Response to the first reviewers' comments (RC2) on the paper "Modeling interactions between tides, storm surges, and river discharges in the Kapuas River delta".

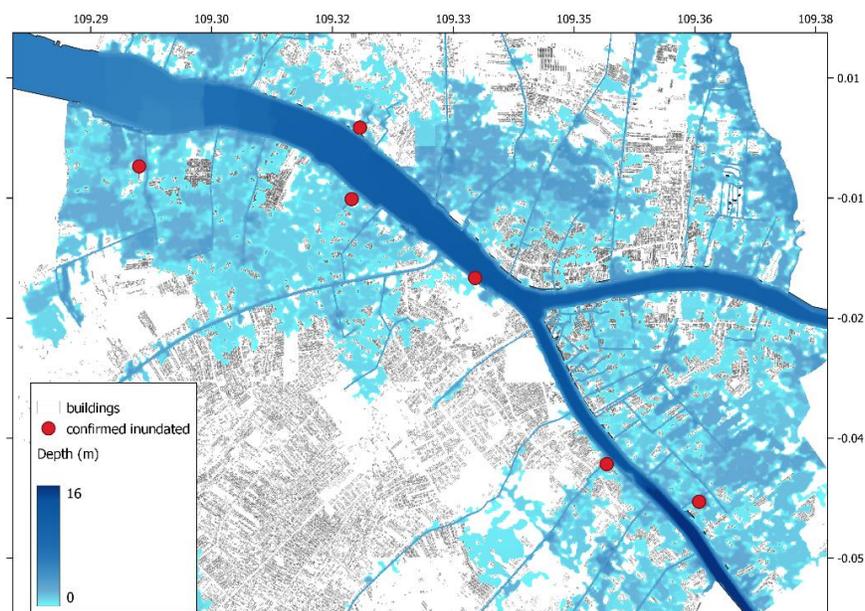
• The model only predicts flooding at locations near the river (c.f. line manuscript line 242), but the flooding might propagate much further into the city through the drainage channels, which seem not to be well resolved by the model. The SRTM DEM used in this study only states the surface level, the depth and hence flow velocity in the channels will be underestimated. The 30-m resolution furthermore does not horizontally resolve the channels, which are on average 5m wide. The same applies to streets. This is aggravated by the peculiarity of SRTM to measure the highest point within each pixel.

Response: The highest resolution of our mesh is 50 m; therefore, this level of detail is unreachable for our hydrodynamic model. Since our domain is very wide, using a mesh with a higher resolution than 50 m will make the computational cost expensive, and the non-hydrostatic effect will become non-negligible. As a solution, for a better inundation map extent in the case study, we re-ran a new simulation using another model HEC-RAS (2022), where the boundary conditions are set based on the output of the SLIM model. The domain of this new simulation is only enclosing the city of Pontianak. This new simulation uses 10 m mesh resolution and replaces the SRTM using a higher resolution DEM from DEMNAS (<https://tanahair.indonesia.go.id/demnas/>). The new DEM map has a 0.27-arcsecond (about 8.3 m) resolution. Therefore, using this strategy, we could evaluate the flows inside the canals that drive inundation over locations far from the river banks. We then modified the flood extent map as follows:

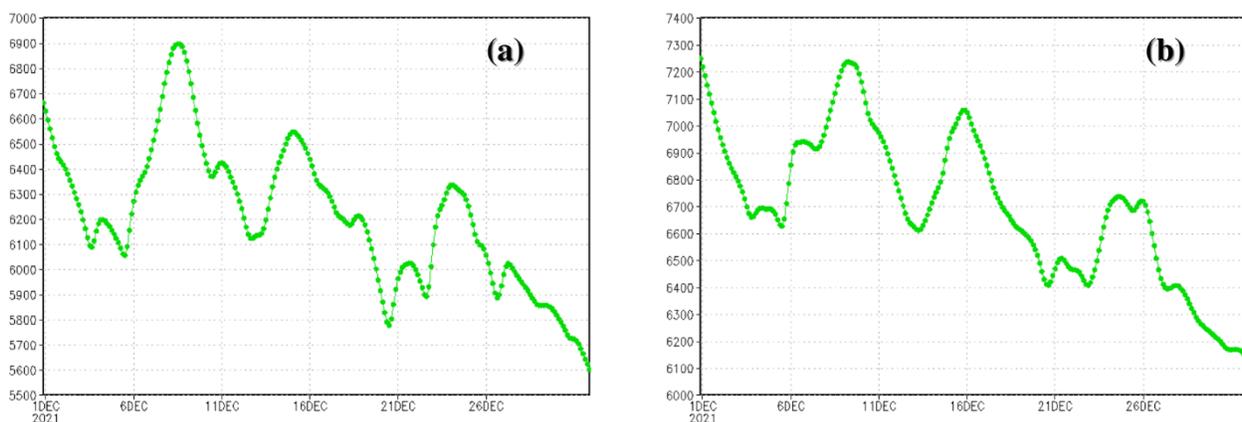
116 *A threshold of 0.5 m seems to be too large for elements to be considered dry since flood height in the city is of the same magnitude.*

Response: We re-ran the simulation using $h^* = 0.1$ m as the threshold and used a higher resolution of DEM and a higher mesh resolution in the case study; therefore, the inundated area extent is now changing.

The bathymetry map around the Kapuas Kecil river mouth from Garmin (<https://webapp.navionics.com/?lang=en#boating@10&key=kpIw%7Bmys>)

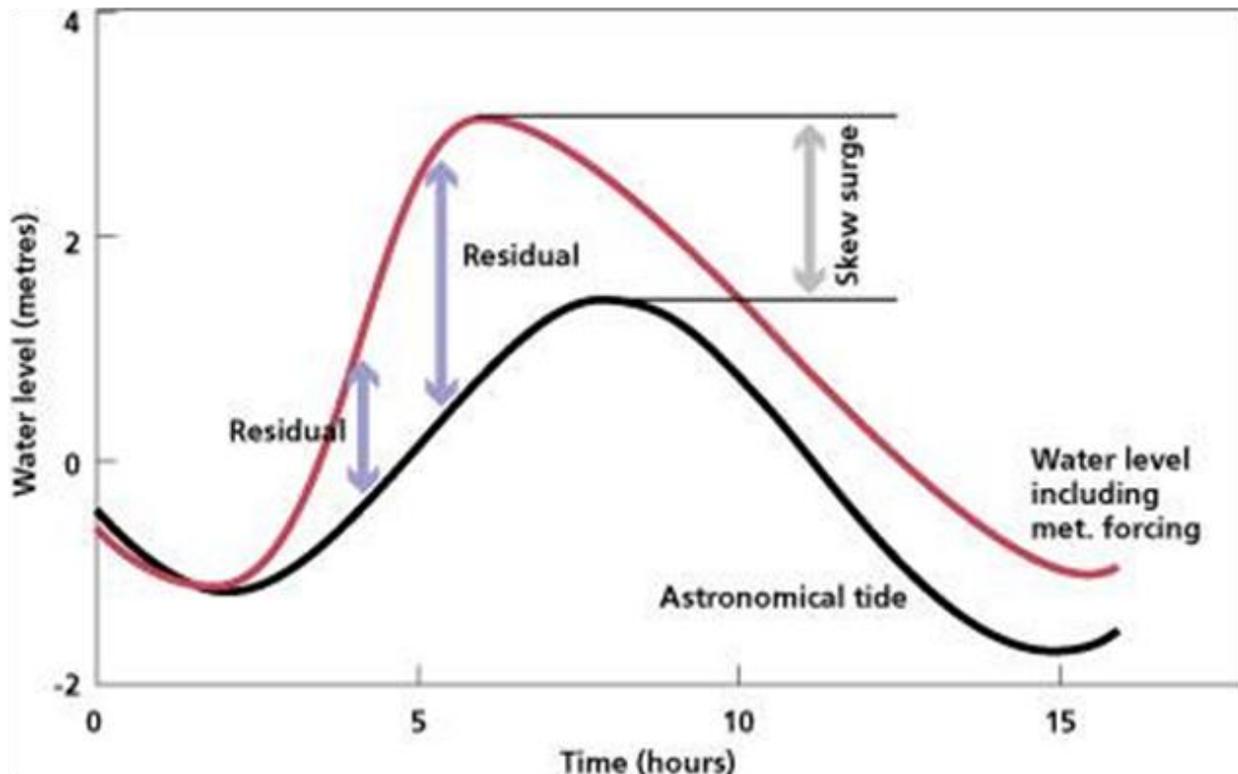
• The bathymetry inset of the Kapuas Kecil shows locations with unreasonably shallow depth of just 3 m, much lower than the thalweg depth of 12 m. This might be due to bathymetry having been directly interpolated from raw data collected by Kastner et al. (2017). The raw data contains stretches of invalid shallow depth gauging due to faulty echo sounding which must be removed by preprocessing for obtaining a reasonably accurate bathymetry.

Since we used the Wetting-Drying algorithm, we used both positive (underwater) and negative bathymetries (dry area from DEM) altogether. So, the bathymetry values in the map range from -3 m (upper mean sea-level) to 100 m (under mean sea-level). Minus values represent the dry area and vice versa. The blue areas represent the dry land. For the locations around the river mouth, we compared our bathymetry with the bathymetry map from Garmin (see Figure below). Overall, we found that the river mouth bathymetry is similar (which is shallow).

Regarding the Thalweg depth, there is a narrow-deeper flow path for the shipping route, which cross the river mouth (see figure above). However, as we saw in our field trip, ships still cannot pass through this flow path during low tide sessions due to its shallowness. In addition, the bathymetry should also be smoothed in our simulation to make it run stable. The smoothing process is based on mesh points, where, unfortunately, the highest mesh element cannot capture whole of this narrow-deeper path. In some parts, the smoothed map overlays this narrow path using

interpolated depth among its surrounding areas. This is the shallow area, which may you saw on the inset map.

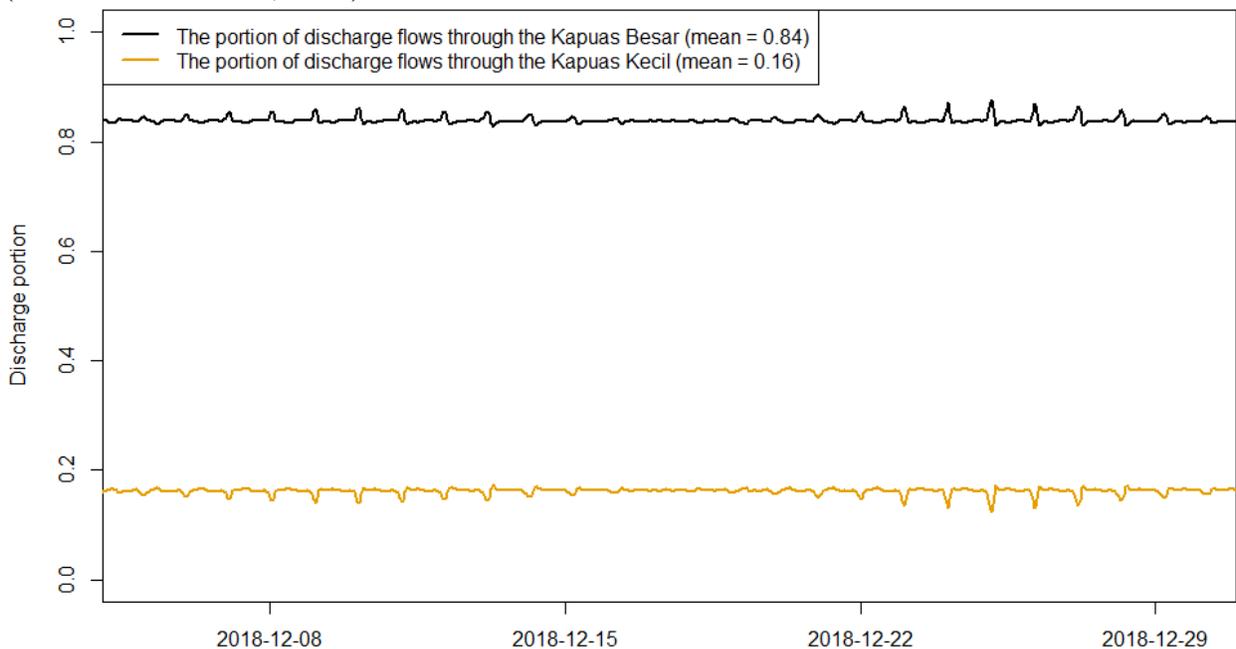
• It would be informative to state which fraction of the discharge of the Kapuas is diverted into the Kapuas Kecil towards Pontianak, and to compare this with previous measurements (Kästner and Hoitink, 2019).

Response: We calculated the portion discharge of Kapuas, which diverted through the Kapuas Kecil branch during December 2018, is about 16% (see Figure below), while 84% continue to flow through the Kapuas Besar. This result is close to the observational data, which stated that 17% of the Kapuas discharge flows into the Kapuas Kecil, and 83% continue along the Kapuas Besar (Kästner and Hoitink, 2019). We added the information to this section.

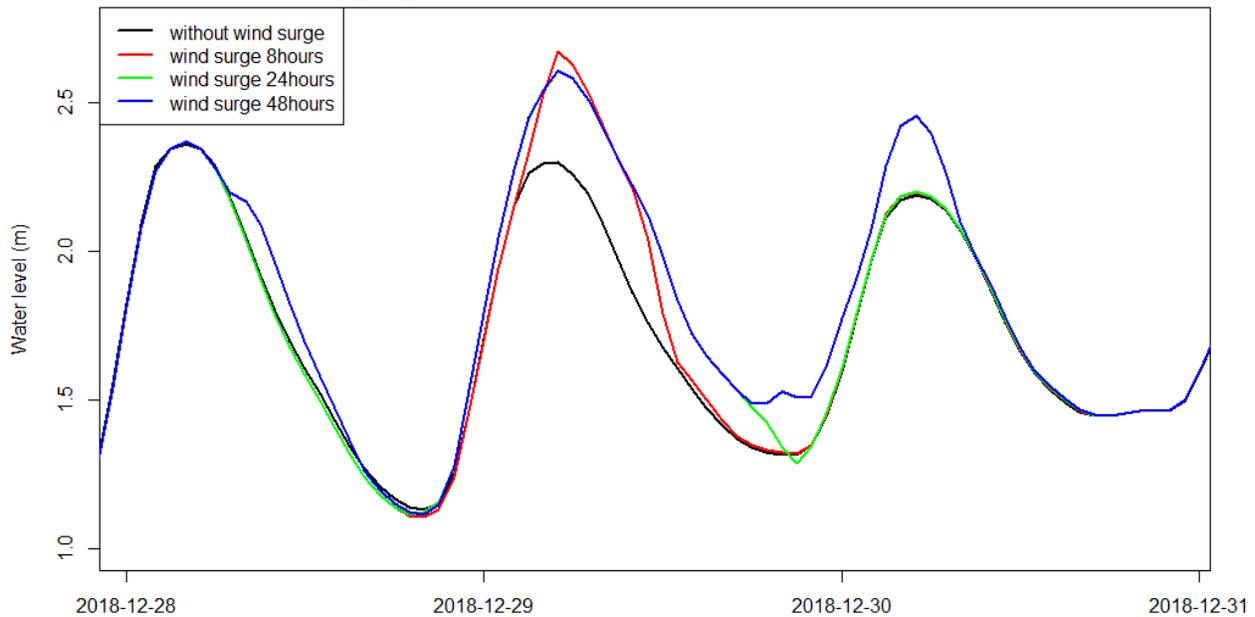
• Discuss how the storm duration may influence the surge. Currently, only the wind force is studied.

Response: The suggestion has been followed. We added wind surge duration impacts in this section. We added following figure:

“Besides the wind velocity, the flood duration and flood extent along the river are also influenced by the storm duration (Höffken et al., 2020). Figure 10 shows that the impact of the wind surge

duration on the maximum water level is not significant, but the flood event occurred longer. Backwater comes from the river mouth upstream and stays longer inland before flowing back to the ocean.”

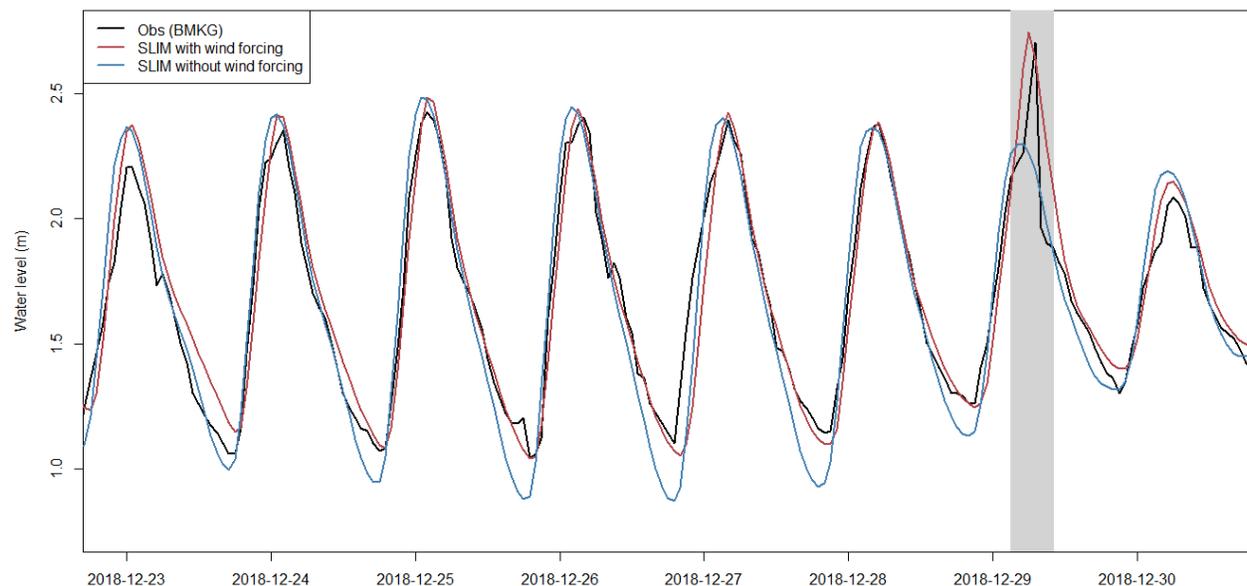
227 Figure 10: It would be informative to include model results (or just a fit) without wind forcing for a comparison.

Response: The suggestion has been followed. We updated Figure 10 by adding the water level dynamics in Pontianak, which simulated without wind forcing. As seen in the figure, based on the "without wind forcing" scenario, the peak water level within the tidal cycle during the event day should be lower than the peak in the previous day. Therefore, the storm is responsible for a 30 cm increase in the water level (grey box in the figure). In addition, the water level surge happened after the tidal cycle passed its peak and in the move to decrease.
